EASTONVILLE ROAD FROM LONDONDERRY DRIVE TO REX ROAD SEGMENT 1 IMPROVEMENTS STATIONING 14+19.69 - 47+66.51

OVERALL SHEET INDEX	
SEGMENT 1	SHEETS 1-42
SEGMENT 2	SHEETS 43-96

EDARP FILING NO. CDR2321

D-R HORTON
America's Builder

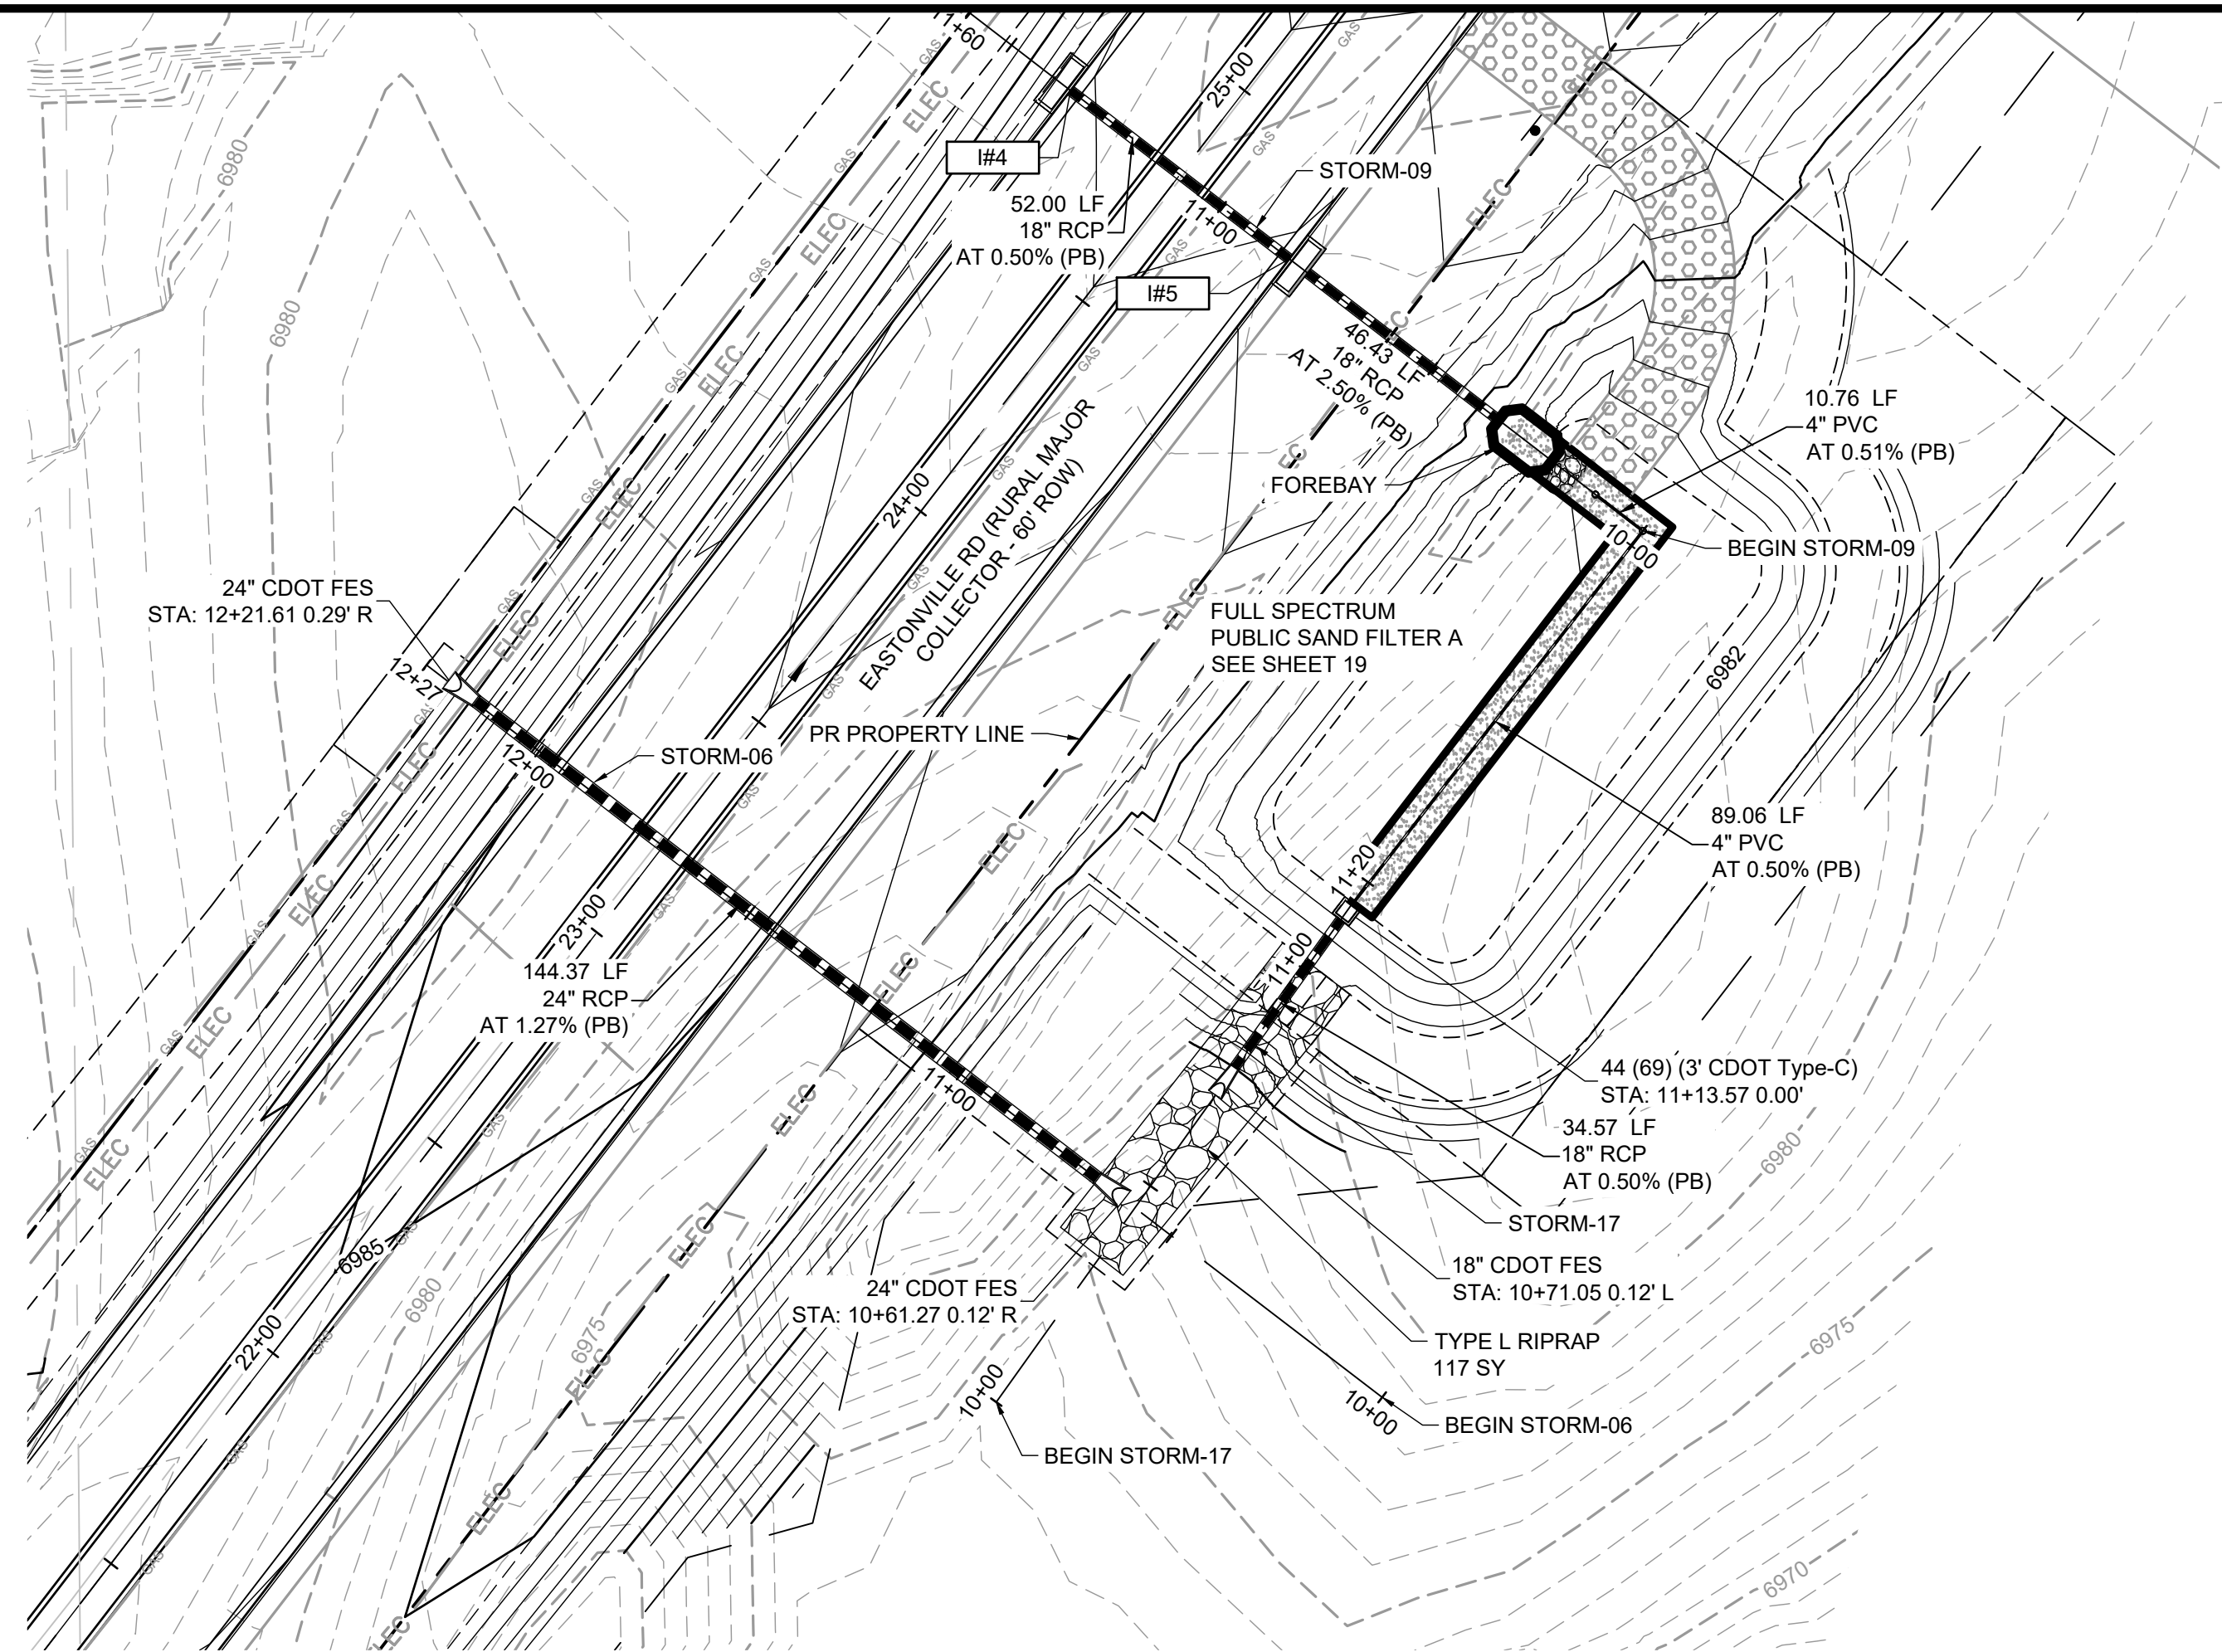
Unresolved:
Label all storm infrastructure
as public or private (All storm
sheets)

Unresolved:
5-yr HGL's need to be
shown wherever pipes are
surcharged for 100-yr
design (all storm sheets)

Provide detail or
dimensions for outlet
protection (all storm
sheets)

SHEET
STM.2 32

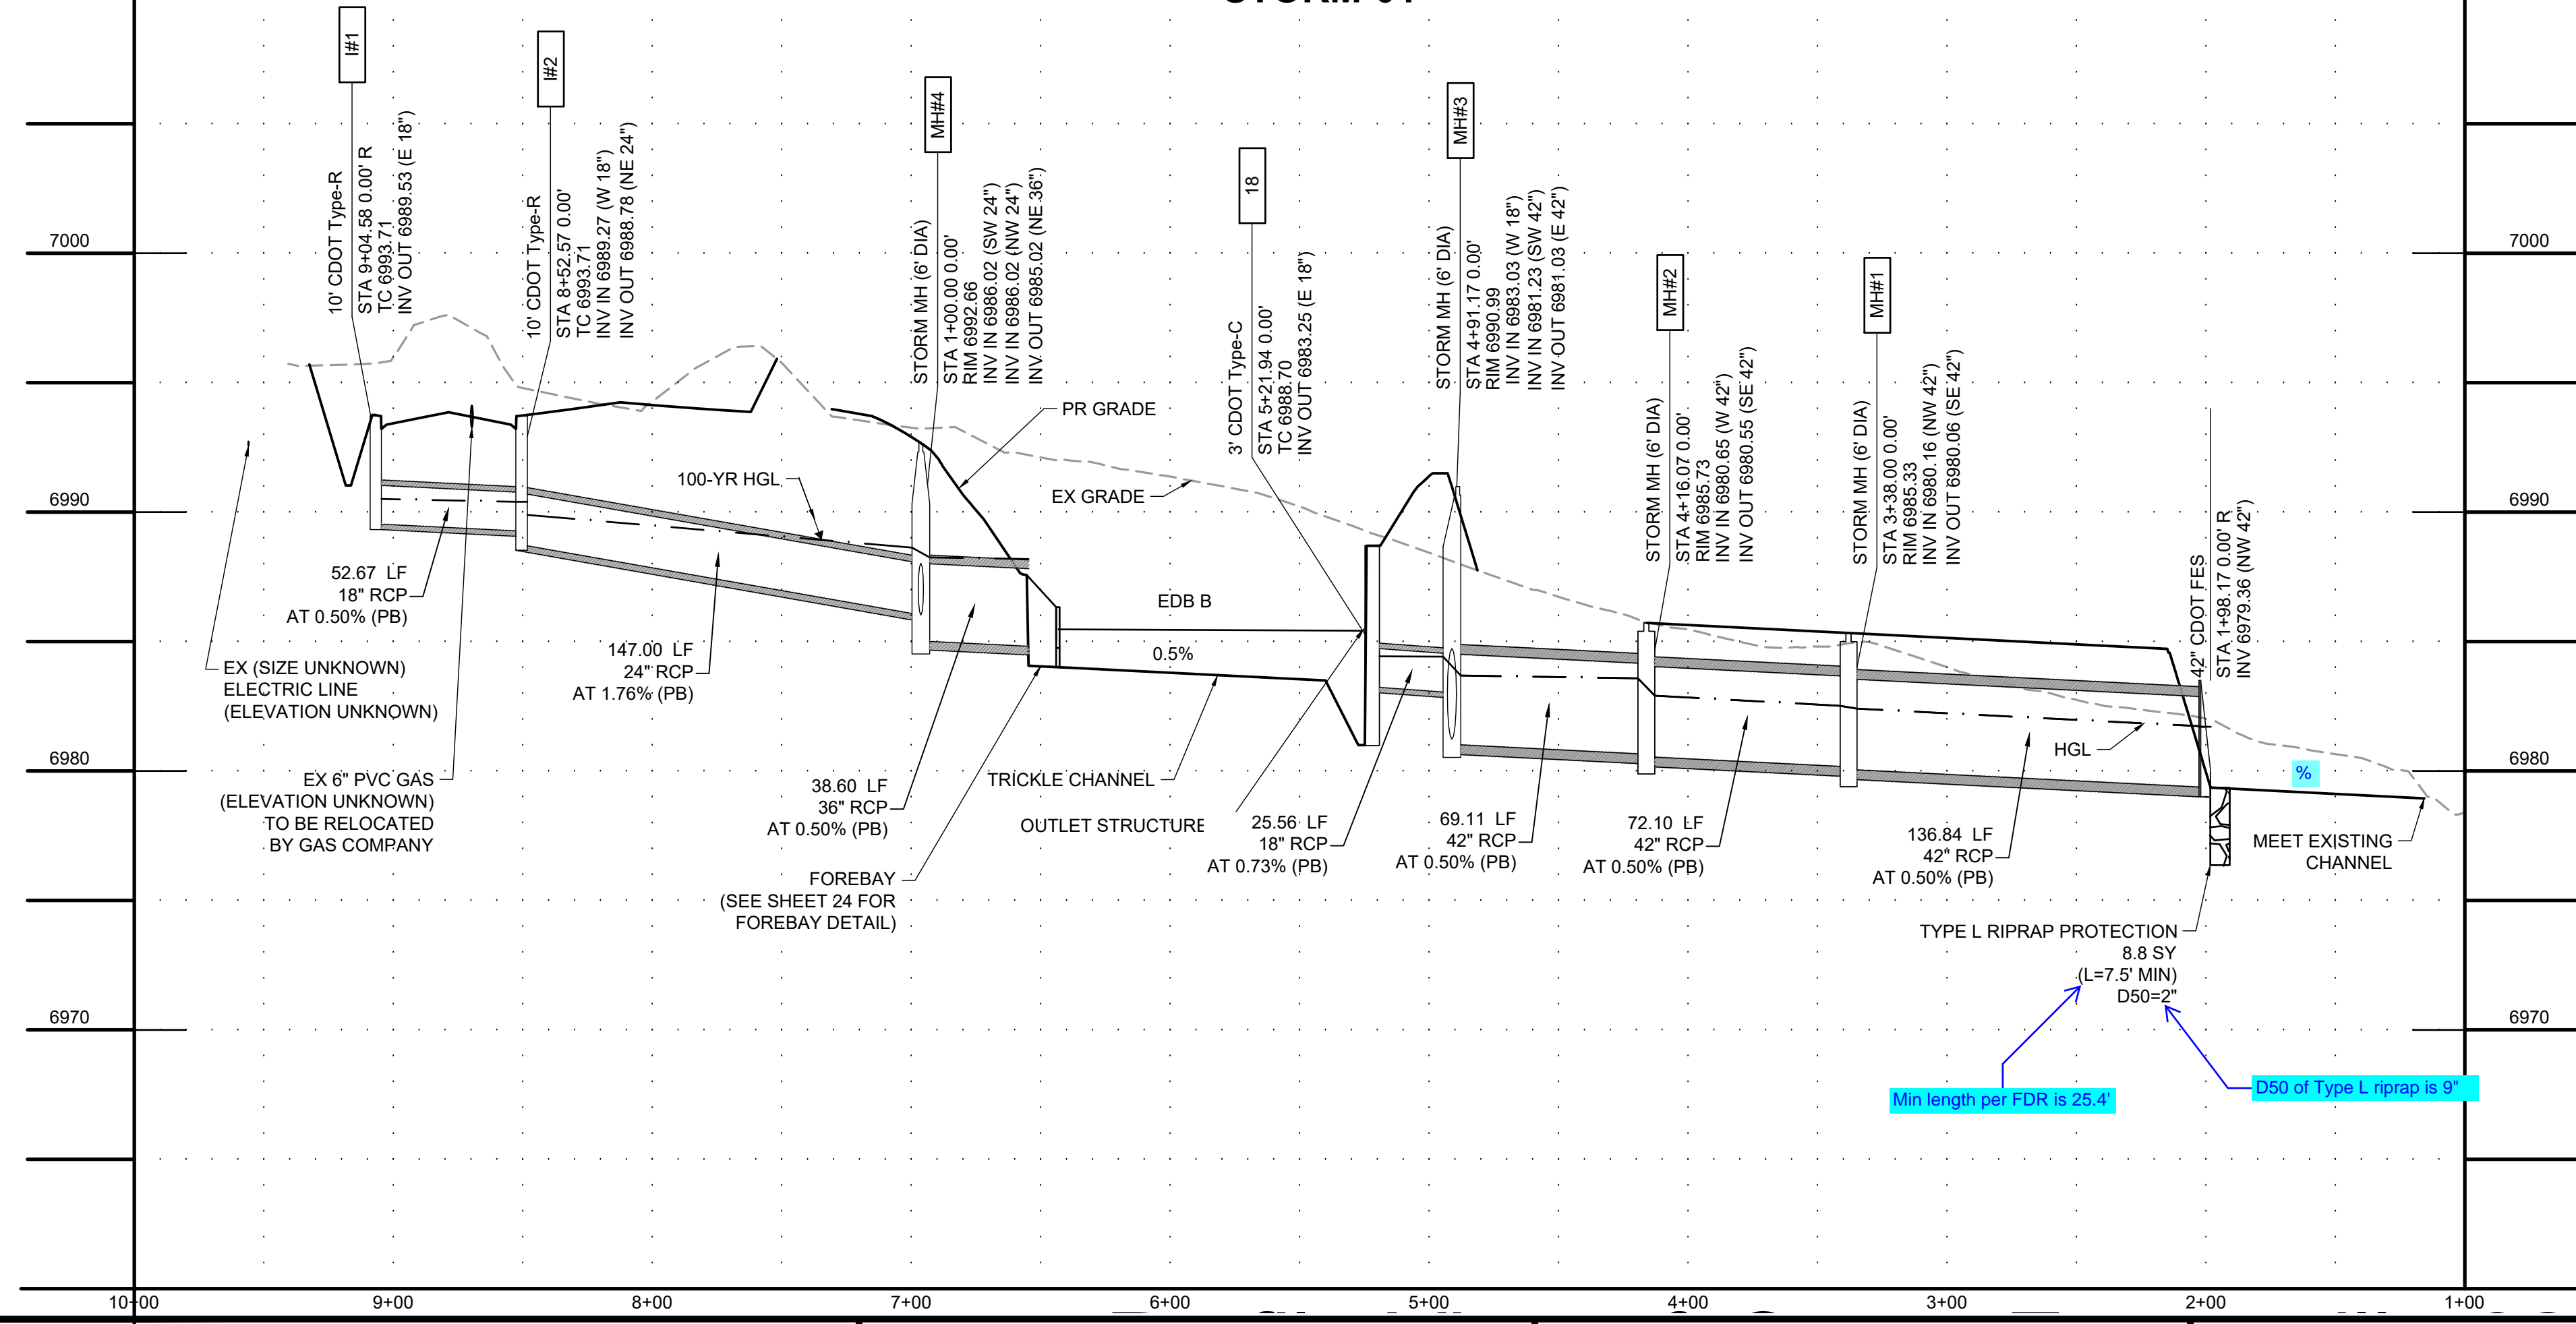
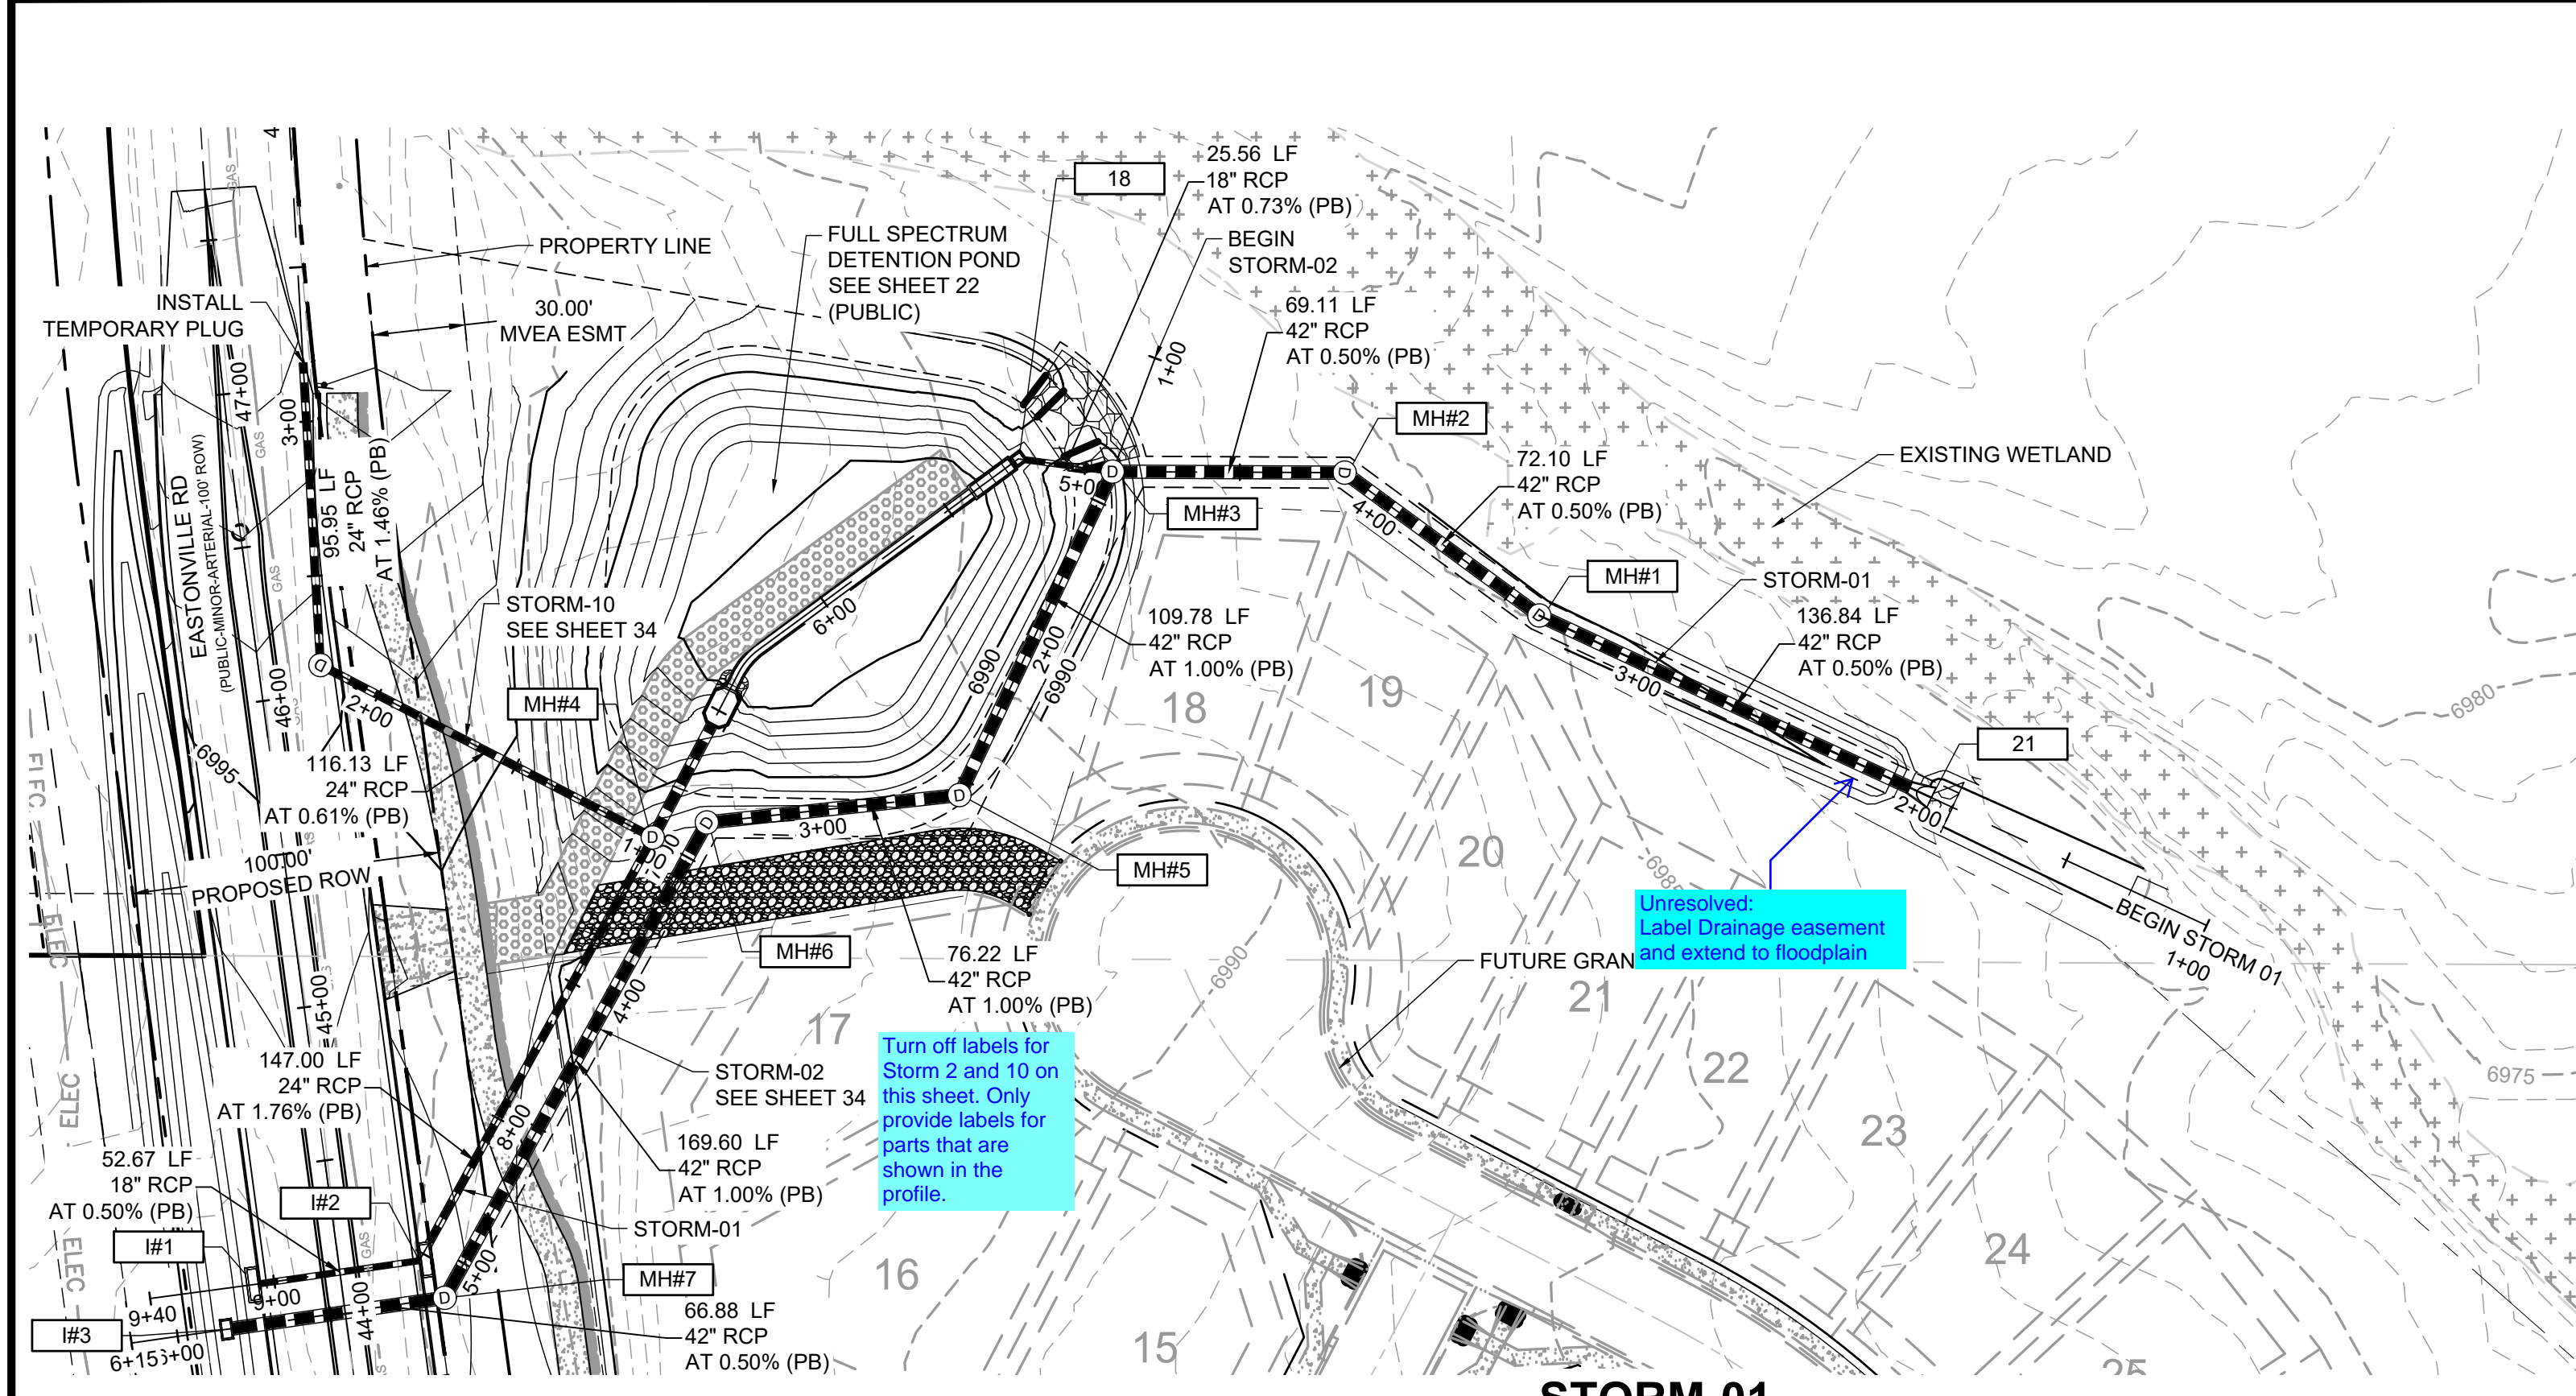
Min length per FDR is 25.4'
